Haulage Routes and Transport Code 9.4.13-2 Part B PO7

Please find below further information that I think should be considered re this development Application where I believe it diversifies away from the City Plan (Version 6).

Attachment B - Proposed 1,000,000 tonnes per annum

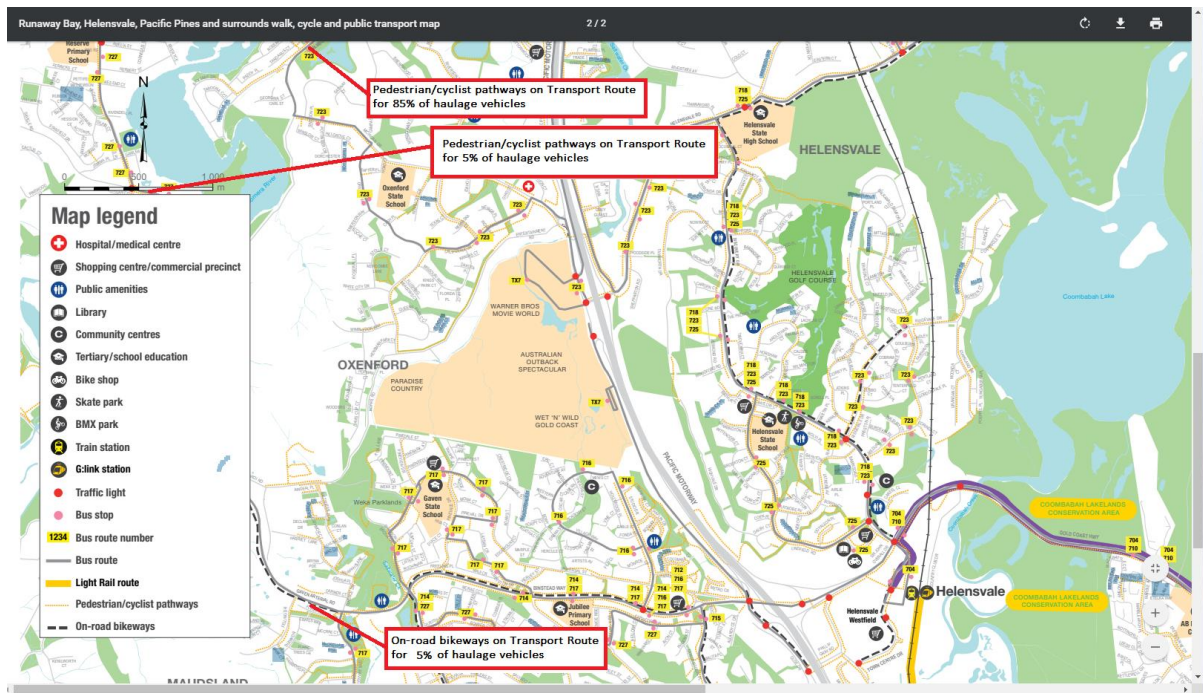
Also, the Council requested: “• The number of haulage vehicles that use this route on a daily basis”. This was not quantified. However, it is clear that the number of haulage vehicles accessing the site has been increasing year on year (Attachment B) and they have previously said 141 loaded trucks (282 trucks in total) per day for year 2017/2018 and a ‘proposed’ 171 loaded trucks per day (342 trucks in total).

Therefore, the answer should be 282 haulage vehicles per day in the year 2017/2018 increasing to a proposed 342 haulage vehicles per day in the future.

Attachment C - Pedestrian/cyclist Pathways and ON-road bikeways

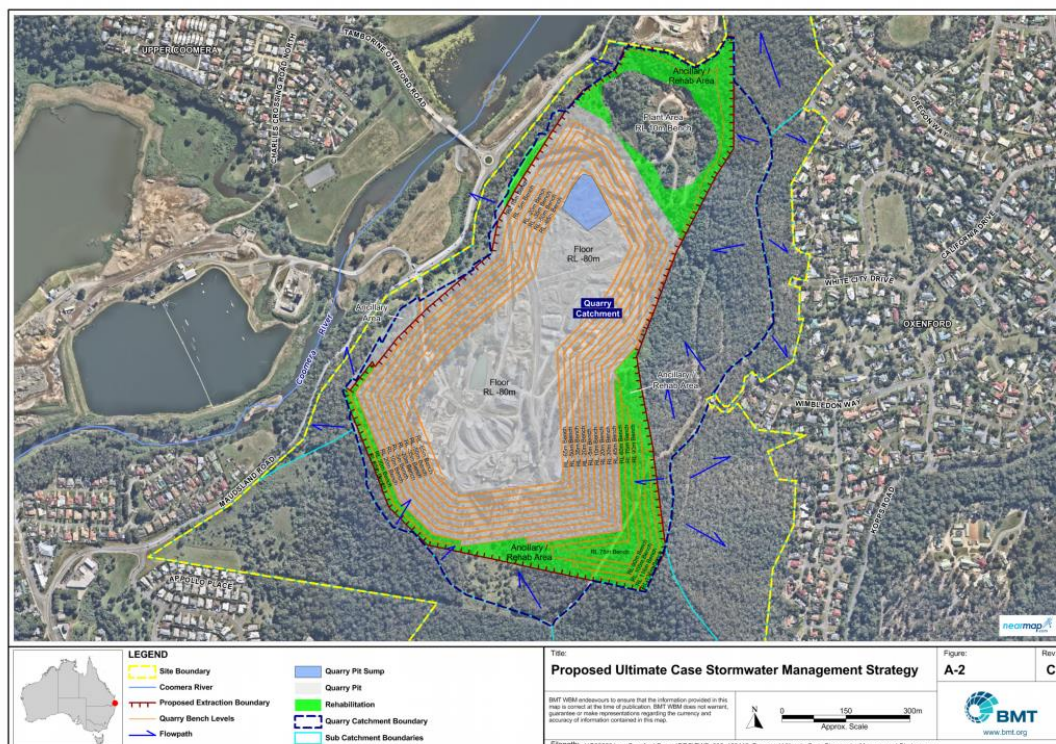
In the Gold Coast travel map (Attachment C) it can be seen that the Gaven Arterial Road is labelled as ‘On-road bikeway’:

Given that a significant number of all haulage vehicles are using this route (Attachment A) a Safety assessment is clearly required but is not provided as part of the development application.

It can also be seen that there is a Pedestrian/cyclist pathways on ‘part’ of the route on the Tamborine-Oxenford road (heading East over the John Muntz Bridge and West to the Pacific Motorway) from the quarry site. Given that the 90% of all haulage vehicles are using this route (Attachment A) a Safety assessment is clearly required, but is not provided, as part of the development application.
